Meeting Date: Tuesday 8 December 2015
Location: Committee Room 2, Level 5, Civic Centre, 1 Devlin Street, Ryde
Time: 5.00pm

NOTICE OF BUSINESS

2 95 BALACLAVA ROAD, EASTWOOD - LOT 6 DP 35226 Development Application for a new two storey boarding house comprising twelve (12) boarding rooms under State Environmental Planning Policy (Affordable Rental Housing) 2009. LDA2015/11.

**3 38 CONRAD STREET, NORTH RYDE - LOT 23 DP 222878. Section 96(1A)
Application to modify consent for alterations and additions to dwelling.**

Figure 8 – Diagram showing the proposed car parking area. Noted in this diagram is how the parking area proposes to accommodate the disabled parking space and shared zone.
Source: Submitted ground floor plan edited by CPS

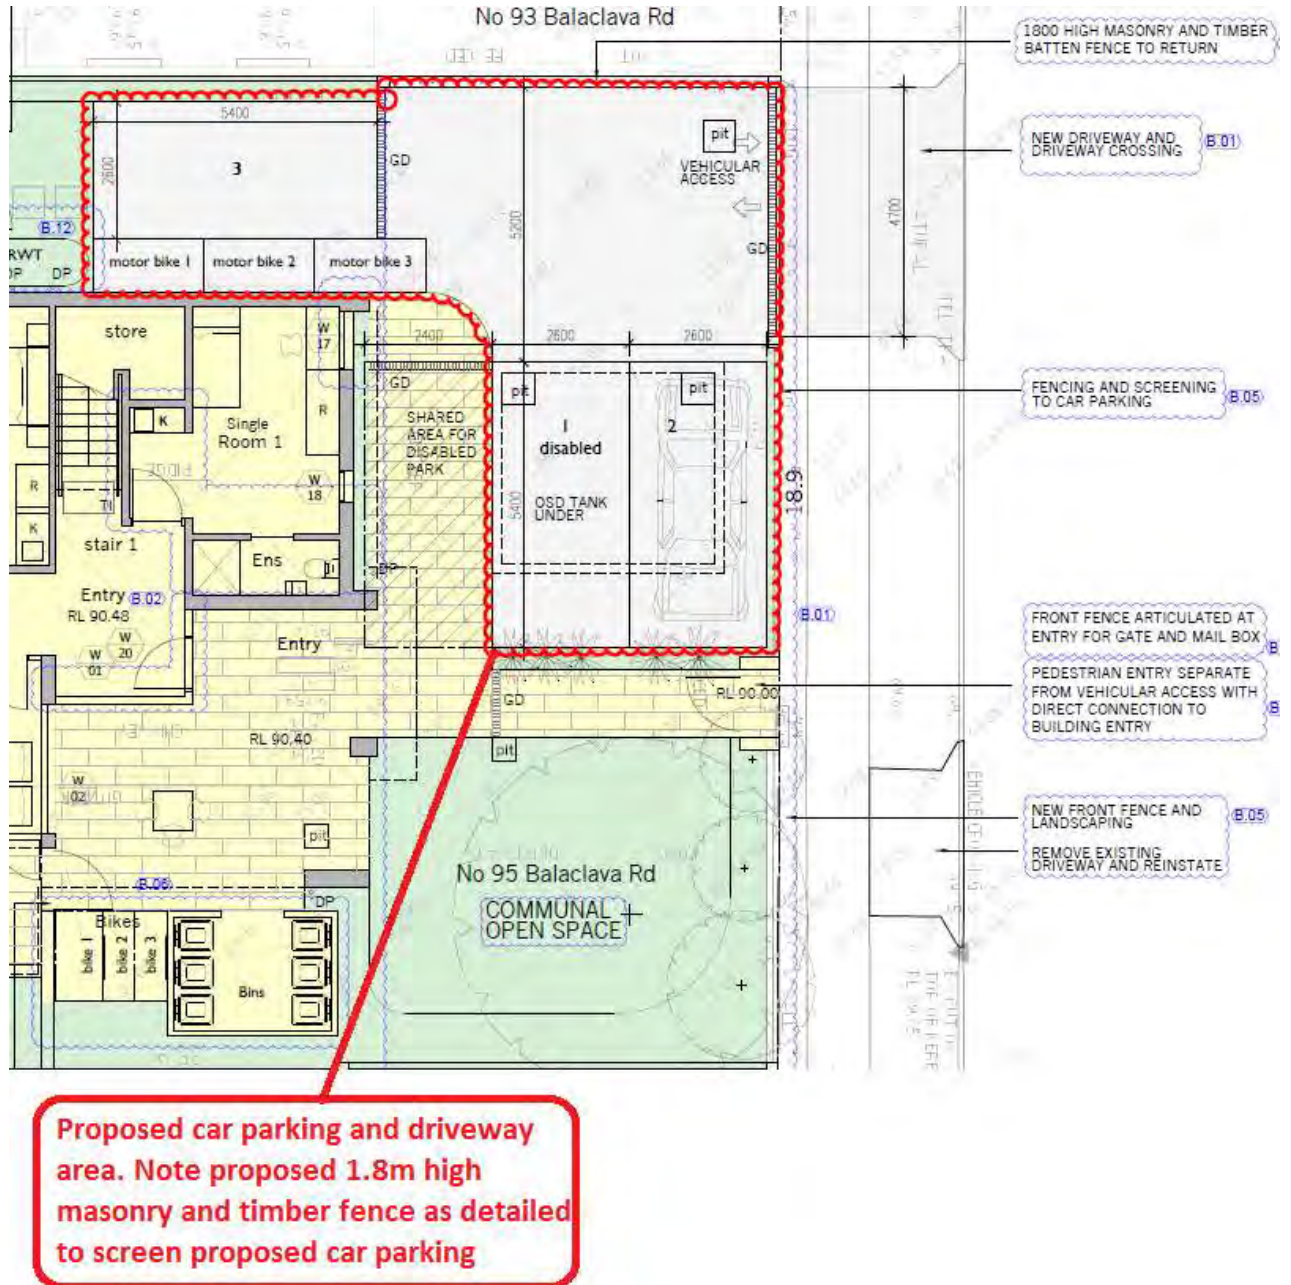
An assessment of the submitted architectural plans has revealed that parking for the proposed boarding house is in the form of an uncovered hard stand parking area and as such does not incorporate a garage or car port structure. Two (2) parking spaces including one (1) accessible space is located within the front setback (see **Figure 8** below). One (1) additional car parking space and three (3) motorcycle parking spaces are located within the western side setback.

parking can be provided behind the building line. The area currently shown to be car parking can then be replaced with landscaping to enhance the appearance of the development whilst also ensuring compliance with Council’s DCP controls.

Figure 9 – Diagram showing the proposed front fence to screen the proposed car parking area within the front setback.

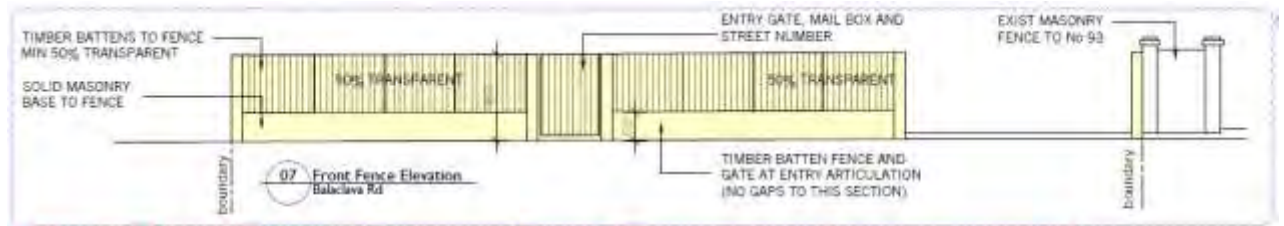
1.8m high and 50% transparent front fence proposed to screen car parking areas within the front setback.

Figure 10 - Reduced side facing terrace with increased landscaping in response to Council's concerns.

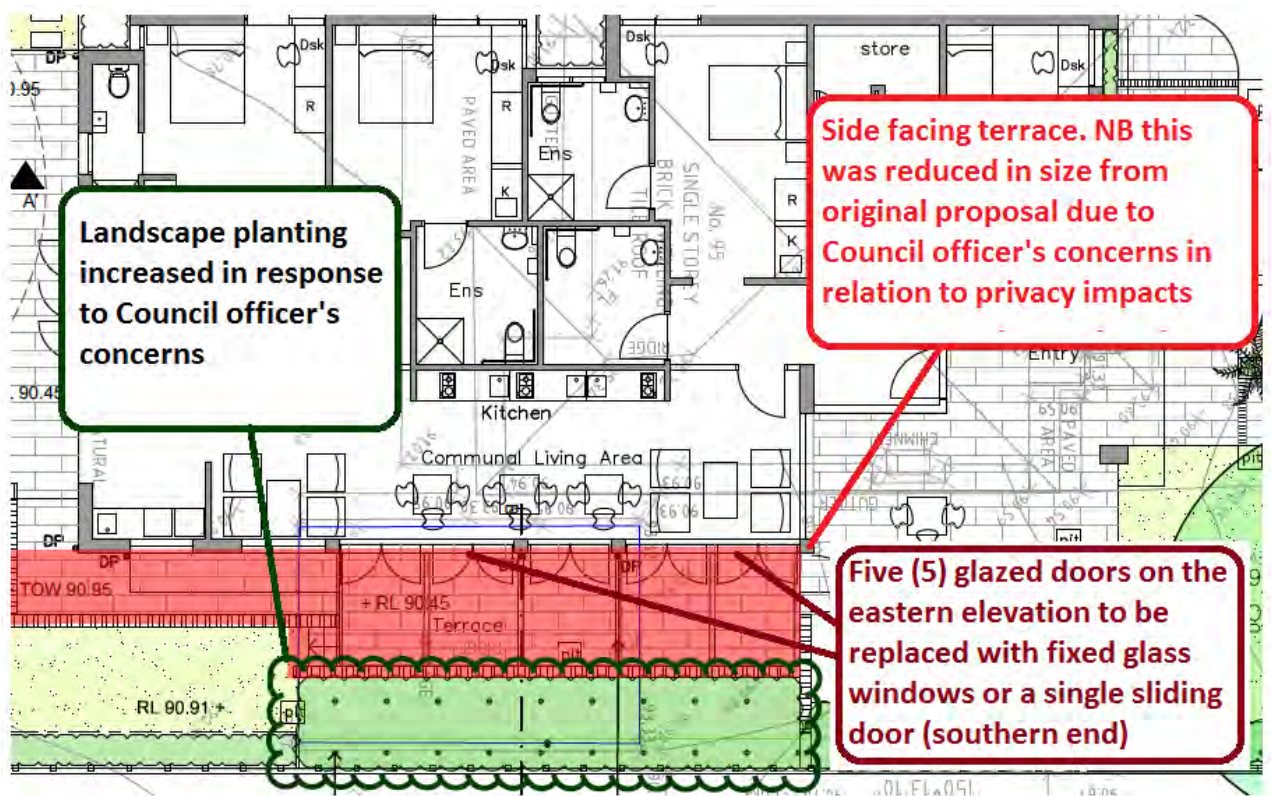
It is considered that the design of the development as currently proposed in the amended plans could give rise to unacceptable visual and acoustic privacy impacts upon the neighbouring property, notwithstanding that the proposal has been amended to provide increased landscaping (see **Figure 10** below), and that no objection has been received from this adjoining property owner. It is therefore recommended that this matter be addressed via the following Deferred Commencement condition.

Communal Living Area windows. To ensure acceptable visual and acoustic privacy impacts on the adjoining property immediately to the east, the five (5) glazed doors on the eastern elevation to the communal open space shall be replaced with fixed glass windows or a single sliding door (at the southern end) that will provide a smaller opening.

Figure 11 Rear facing stairwell window to be conditioned to incorporate obscure glazing
Source: Submitted elevation plan edited by CPS

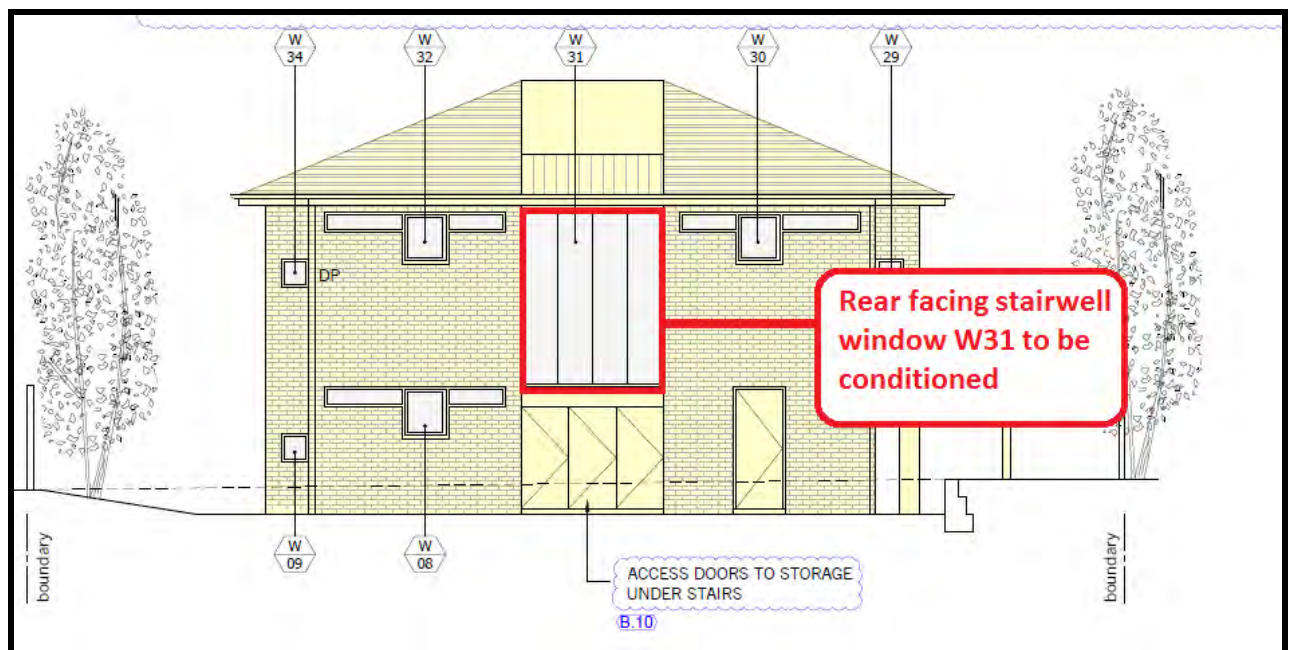
Nevertheless, given the concern in relation to privacy impacts from the subject stairwell window it is considered that a condition be imposed for obscure glazing to be provided to both the proposed stairwells as follows (see Figure 11 and 12 later in this report).

- The side and rear facing windows to the proposed stairwells W38 (rear) and W41 (side) (refer **Figures 11** and **Figure 12**) have the potential to look directly into a side facing window of the adjoining dwelling at 93 Balaclava Road and to the rear private open spaces of 12 and 12A Irene Crescent.
- Room 1 includes a front facing window in proximity to the building entrance, although it is shown to be high level it is considered that an additional privacy measure such as obscure glazing should be included to maximise the amenity to this room (**Figure 13**)

Obscure Glazing Room 1 The north facing window to the en-suite bathroom to Room 1 identified as W18 on the approved plans, is to be modified to include privacy measures. To minimise the potential for direct views into this bathroom, obscure glazing or similar treatment must be installed. Plans that include details demonstrating compliance with this condition are to be submitted and approved by the Principal Certifying Authority prior to the issue of a **Construction Certificate**.

Figure 3 – Extract of elevation from stamped plans of LDA2011/0343 showing the approved elevated driveway structure connecting to the garage on the upper floor of the dwelling.

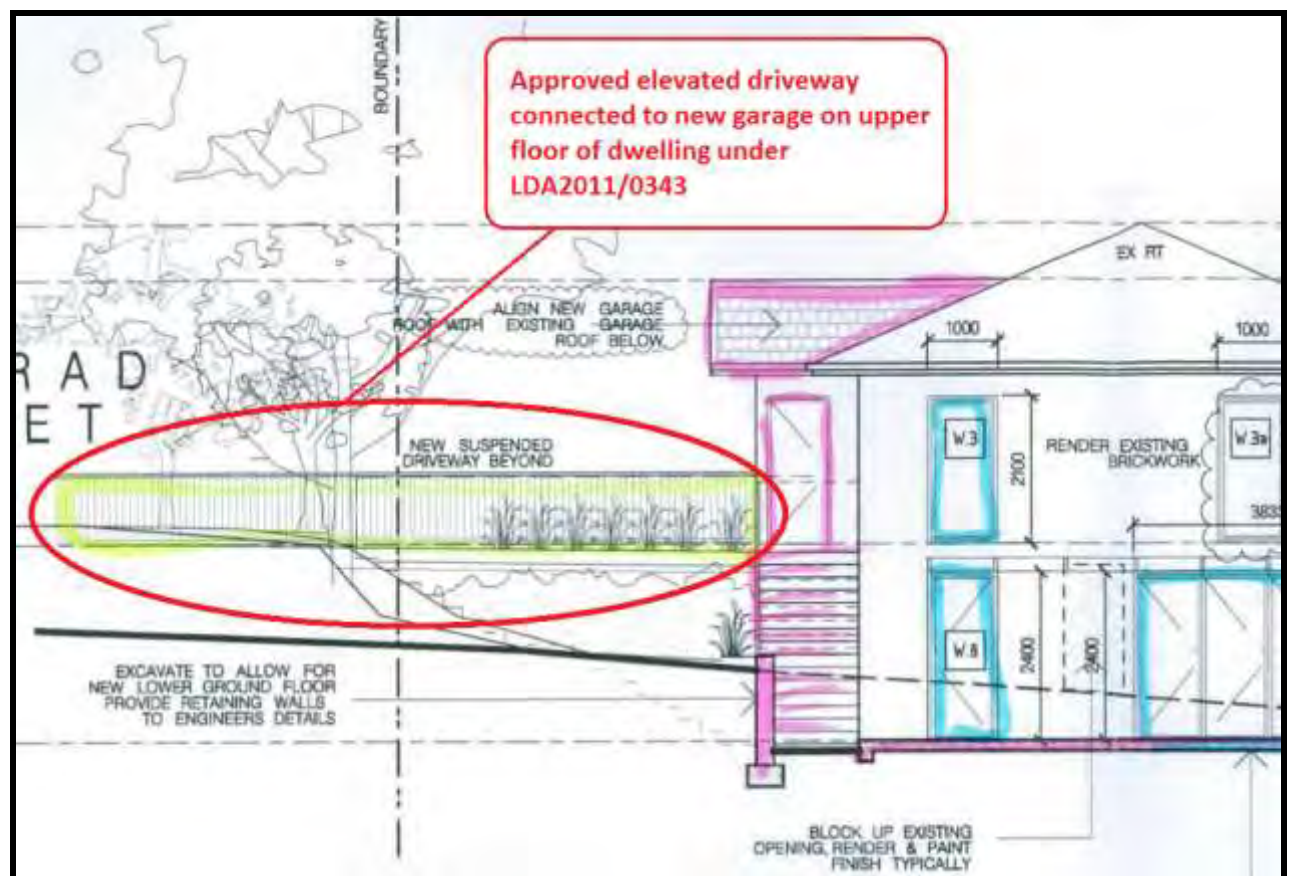
The original DA was approved subject to conditions on 29 November 2011. Importantly for the subject Section 96 application, the DA approved an elevated concrete driveway structure extending from the street frontage to a new garage located on the upper floor of the dwelling house – refer **Figure 3** below.

Figure 4 - An alternative driveway design submitted by the objectors.

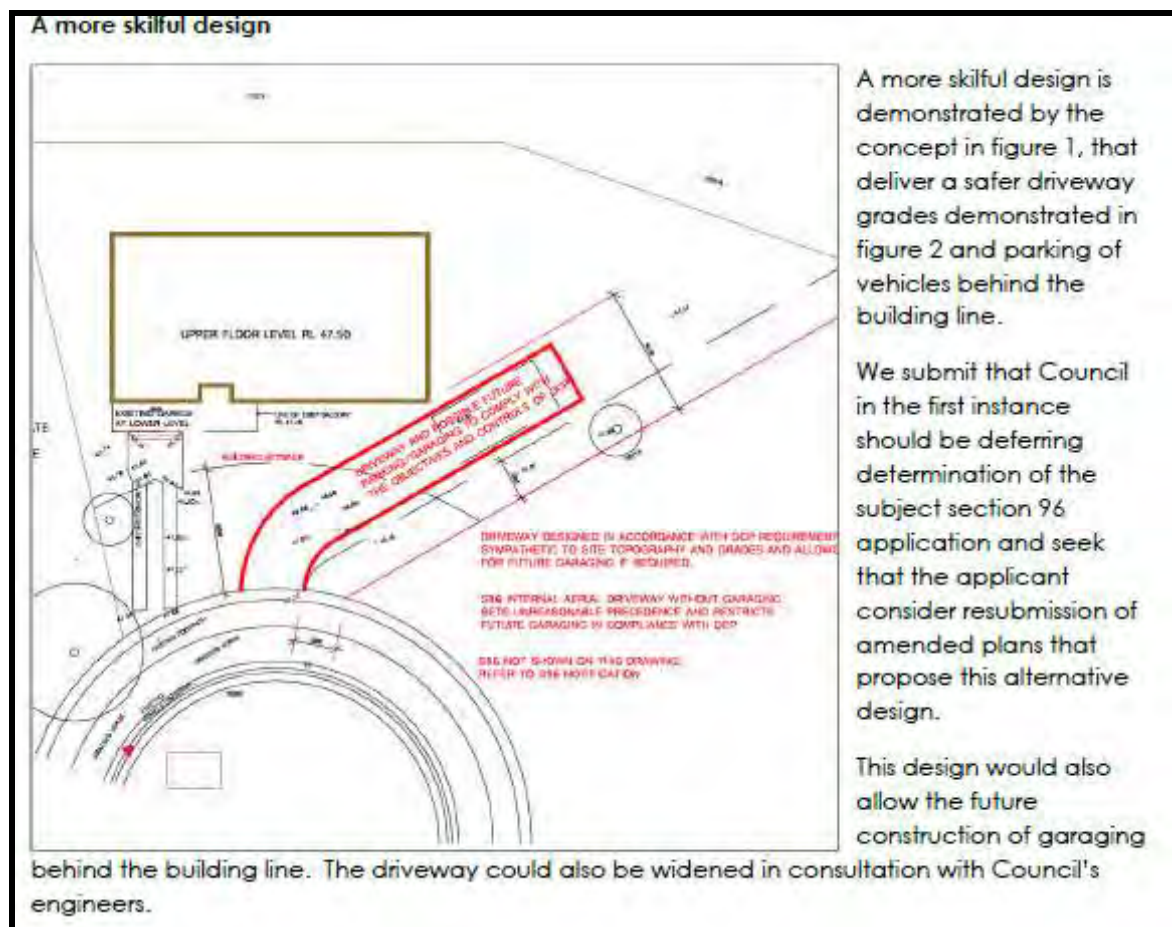
Assessment Officer Comment: The alternative design suggested by the objector was put to the applicant in a meeting on 3 August 2015 - refer **Figure 4** above. The applicant advised that this is not feasible because site preparatory works have already been undertaken including the construction of retaining walls which would conflict with this alternative arrangement.

Figure 5 - Proposed 1.8m privacy screen provided for 5.4m (standard car space length) from the building façade. Note the carport is not approved, but the balcony privacy screen is considered acceptable.

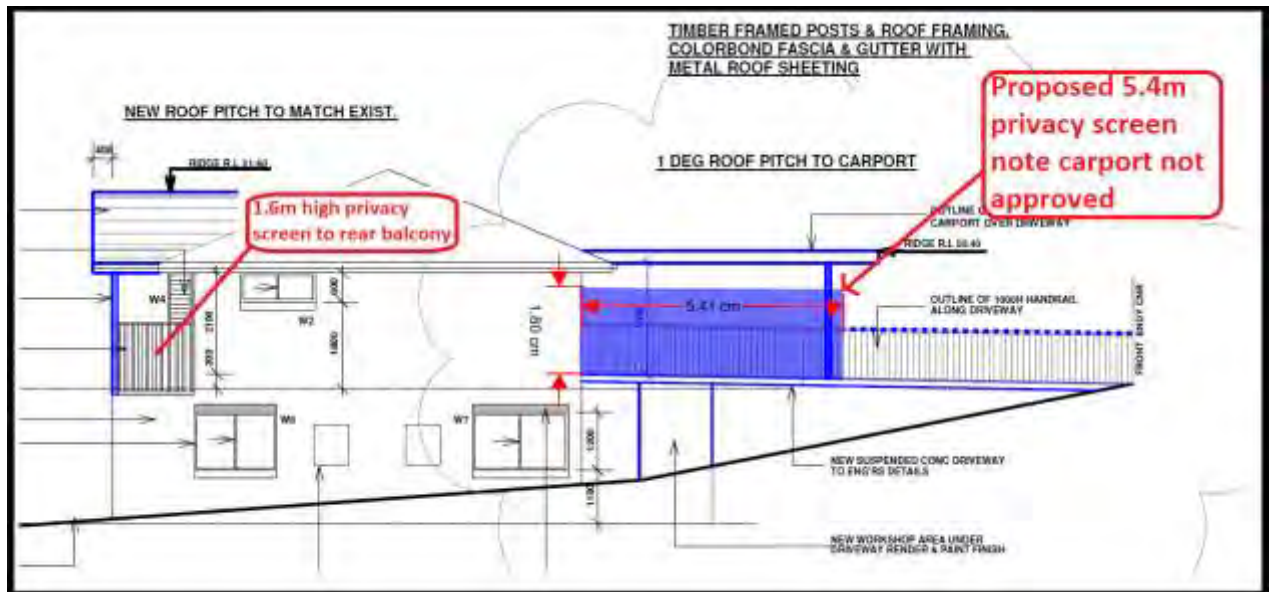
Assessment Officer Comment: The revised plans (see **Figure 5** above) now detail setbacks that are generally consistent with the originally approved development. These are now proposed to be 1900mm (1.9m) at the widest point and 500mm from the northern boundary (at the front boundary). Given the angle of the allotment's northern boundary it is considered that the existing setbacks approved by the original development are generally appropriate and that setting the structure 2m for its entire length would require additional internal and external changes to the development that would be onerous.

Assessment Officer Comment: In respect to recommendations under number 4 from the objector, a condition has already been discussed and is proposed for a 1.8m high privacy screen to address potential overlooking from the elevated structure. This screen will help minimise overlooking given the new use of the structure as a parking platform rather than a driveway. This is shown in **Figure 5** above.

In respect of the proposed 1.6m privacy screen to the rear facing balcony, this is considered an appropriate privacy treatment and it is not considered necessary to raise this to 1.8m. This is because the average eye level of a person is closer to 1.6m rather than 1.8m. The 1.6m high rear balcony privacy screen is also shown in **Figure 5**.

In this regard it is considered that the following condition requiring this 1m fence be increased 1.8m for just 5.4m (standard car length) be imposed to maintain visual privacy whilst also reducing the visual bulk and scale of the structure. The Northern Elevation drawing, edited to show the required 1.8m high privacy screen (5.4m long), is shown at **Figure 5** (above).

Figure 6 – Plan showing side setbacks of proposed driveway.

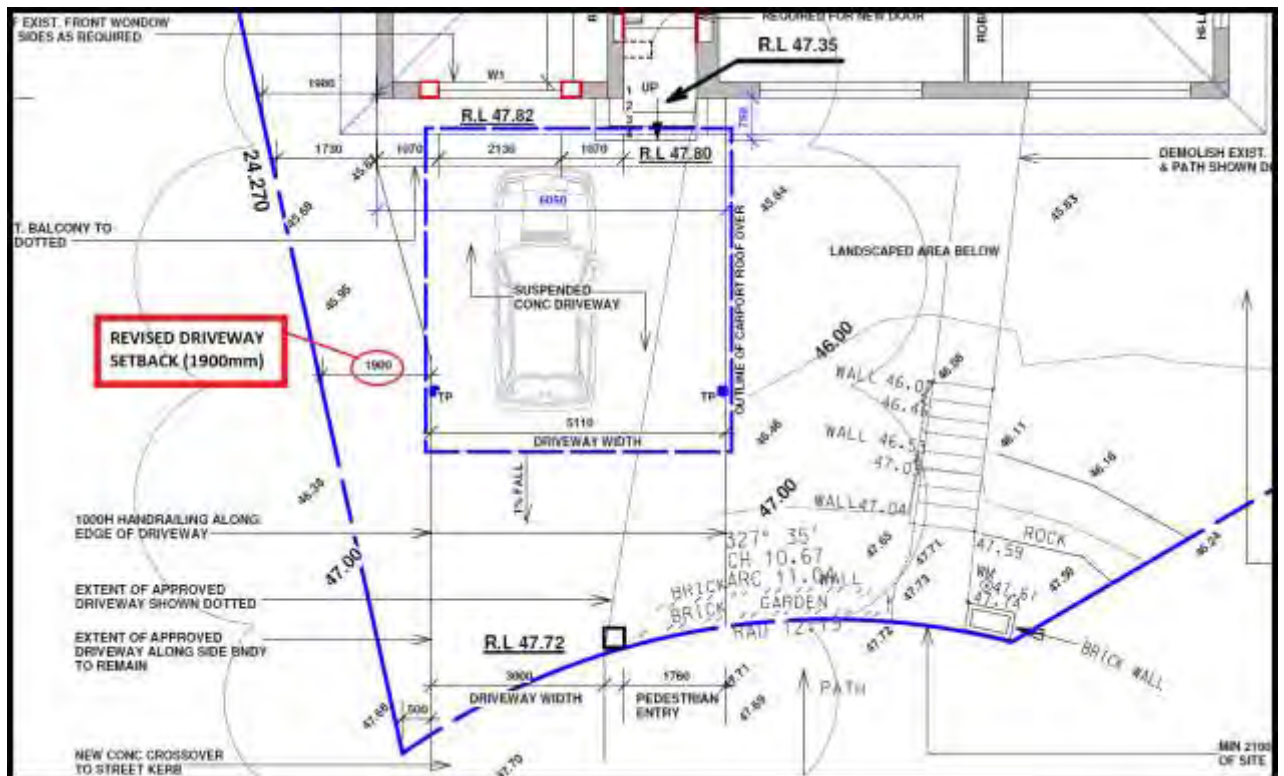
Revised plans were received by Council on 14 August 2015 (and then further amended following a Council request for additional detail on 2 September 2015). These plans illustrate the elevated structure's setback to the northern boundary being more consistent with the setback shown on the original approved DA plans. In addition it is noted that the driveway has been extended to the south to incorporate a more legible pedestrian entry, with separation provided by virtue of a wall at the driveway crossover. A plan of the driveway showing the revised setback of the driveway is shown below.

Figure 7 – View from the elevated ground floor dining room of 36 Conrad Street. An indicative location of parking structure and carport is shown.

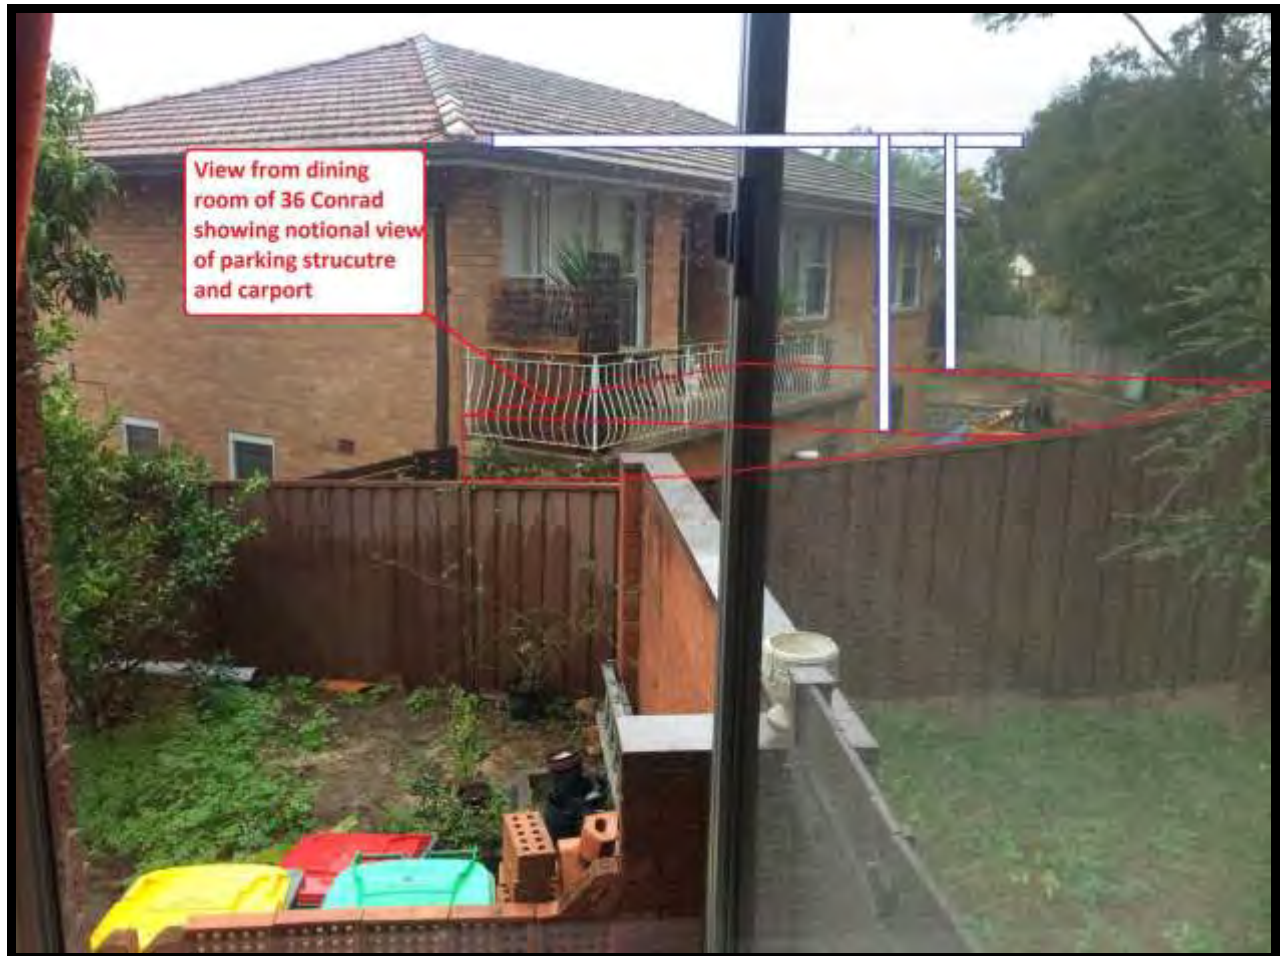
The carport adds further bulk and scale to an approved element that is of considerable scale in the context of the site – see **Figure 7** below. For this reason, it has been recommended that approval of the Section 96 be on the condition that this carport is excluded from the plans via the conditions below:

Carport – The carport shown on the submitted plans A1.01 Ground Floor and Site Plan REV C and A1.03 Elevations REV C and marked in red on the plans is not approved.
